**Staff Report**  
**City of Richmond, Virginia**

**Commission of Architectural Review**

COA-098245-2021	<b>Final Review</b>	<b>Meeting Date: 9/28/2021</b>
<b>Applicant/Petitioner</b>	Alan Adler	
<b>Project Description</b>	Construct a side landing and stairs; install new windows and doors in existing openings.	
<b>Project Location</b>		
<b>Address: 2506 E. Marshall St.</b>		
<b>Historic District: Church Hill North</b>		
<b>High-Level Details:</b> <ul style="list-style-type: none"> <li>The applicant proposes to construct a side landing and stairs on a ca. 1859 masonry, Greek Revival, semi-attached home.</li> <li>The applicant proposes to install new windows and doors in existing, previously bricked-in openings.</li> <li>The proposed stairs and landing will be opaquely-stained wood.</li> </ul>		
<b>Staff Recommendation</b>	<b>Partial Approval</b>	
<b>Staff Contact</b>	Emily Routman, Emily.routman@rva.gov	
<b>Previous Reviews</b>	None	
<b>Conditions for Approval</b>	<ul style="list-style-type: none"> <li>Denial of the shutters on the new, basement windows on the western elevation</li> <li>Staff recommends that the infill brick be recessed in the existing basement door opening in a w

Figure 6. View of side elevation from E. Marshall St.

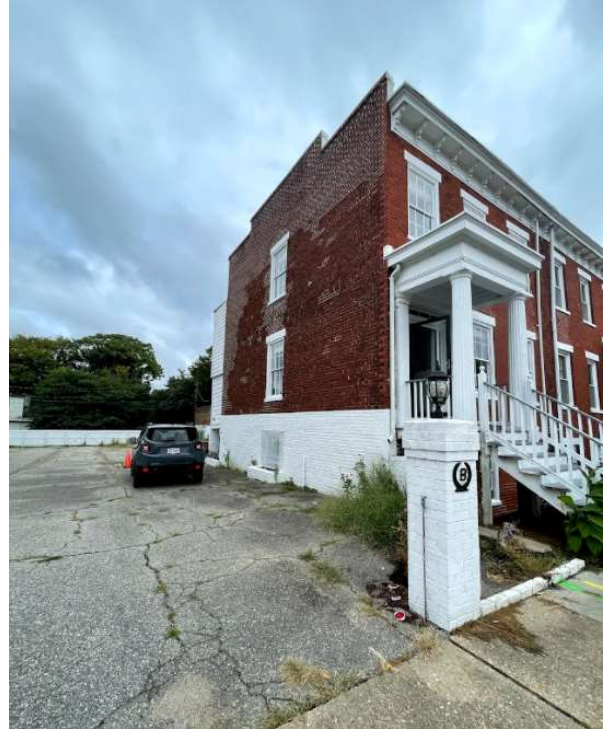
<p>Building elements - Porches, Entrances &amp; Doors, #4, 10, pg. 71</p>	<p><i>4. Do not remove or radically change entrances and porches important in defining the building's overall historic character. Front and side porches are architecturally more ornate than utilitarian back porches.</i></p> <p><i>10. The addition of a new entrance to a primary dwelling elevation is strongly discouraged.</i></p>	<p>The applicant proposes to construct new wooden stairs and a landing on the western elevation of the building adjacent to a new door opening. The railings will be Richmond rail, painted white, a design that is in-keeping with the district.</p>
